SUNDRY NOTICES AND REPORTS ON WELLS
Do not use this form for proposals to drill or to re-enter an abandoned well. Use form 3160-3 (APD) for such proposals.

PLUG AND ABANDONMENT PROCEDURE

Apache 126 #151

Re: Permanent Abandonment
Well: 151 Apache

Proposed P&A

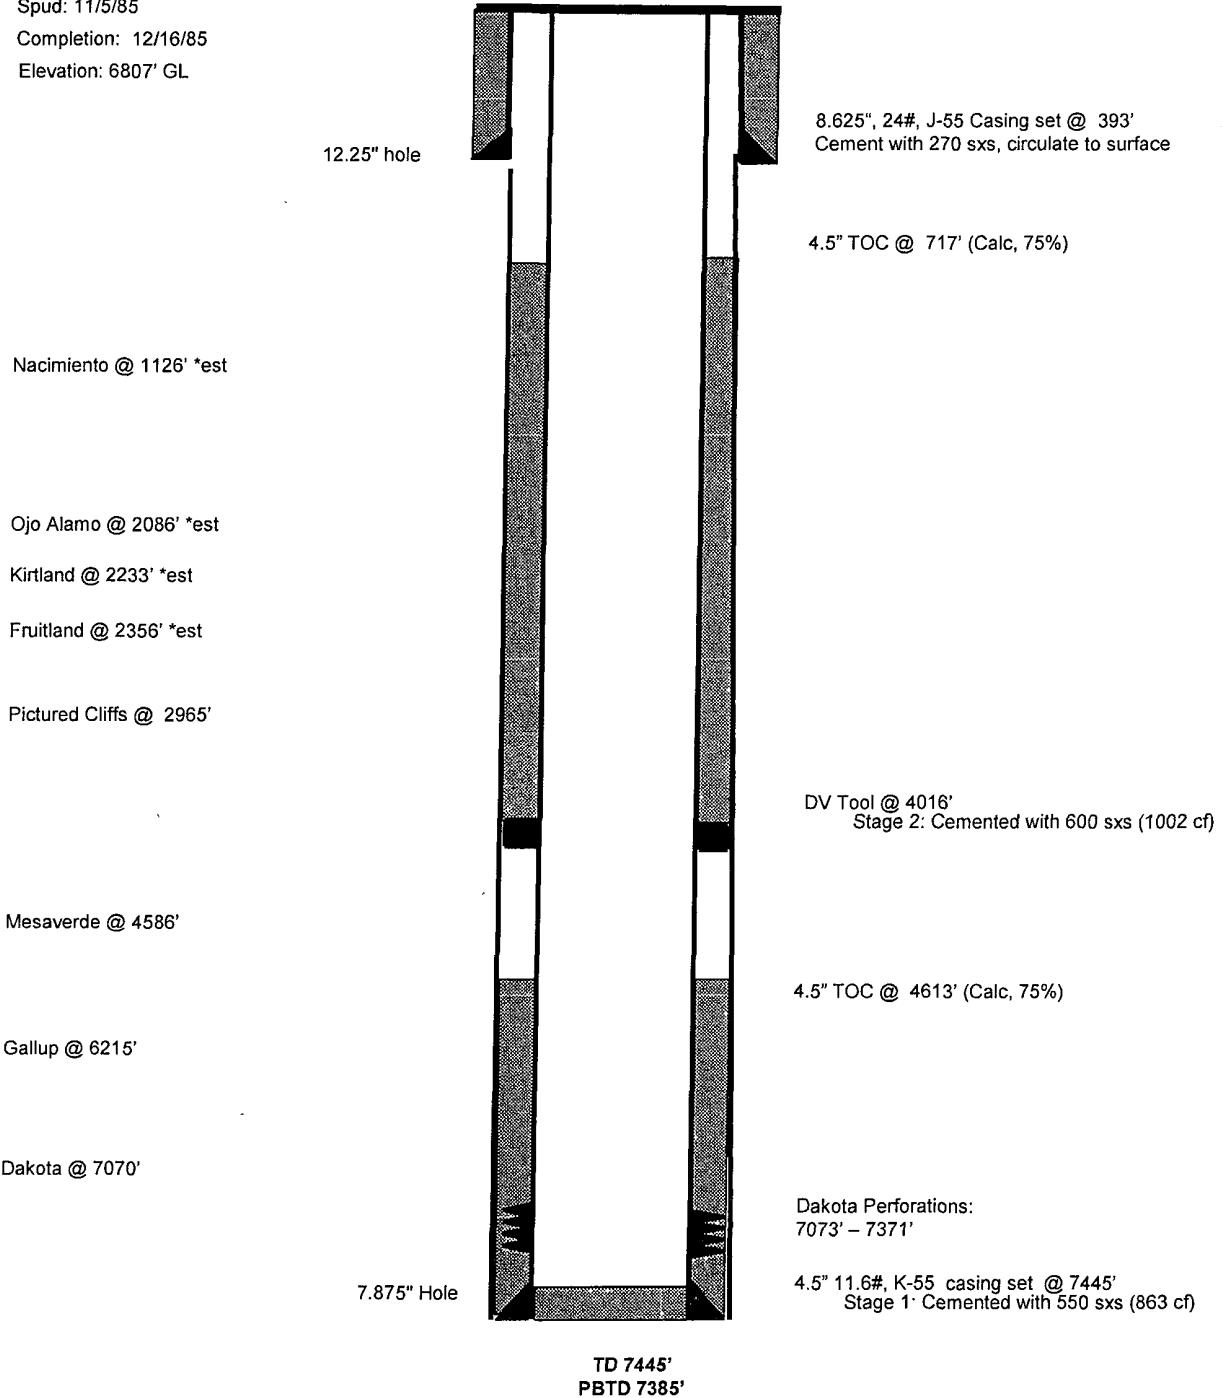
Nacimiento @ 1426' *est
1108

Ojo Alamo @ 2006' *est
2496

Kirtland @ 2233' *est
2677

Fruitland @ 2356' *est
2859

Gallup @ 6245'
6148

Dakota @ 7070'
7148

1158 1058
Plug #6: 1476' to 1076'
Class B cement, 12 sxs

2909' 2436'
Plug #5: 2408' to 2036'
Class B cement, 32 sxs

Plug 3056 - 3756

6198 6098
Plug #2: 6205' to 6145'
Class B cement, 12 sxs

1. Plugging operations authorized are subject to the attached "General Requirements for Permanent Abandonment of Wells on Federal and Indian Lease."
2. Farmington Office is to be notified at least 24 hours before the plugging operations commence (505) 599-8907.
3. The following modifications to your plugging program are to be made:
 - a) Place the Gallup plug from 6198' - 6098'.
 - b) Place a cement plug from 3856' – 3756' to cover the Chacra top.
 - c) Place the Fruitland/Kirtland/Ojo Alamo plug from 2909' – 2436'.
 - d) Place the Nacimiento plug from 1158' – 1058'.
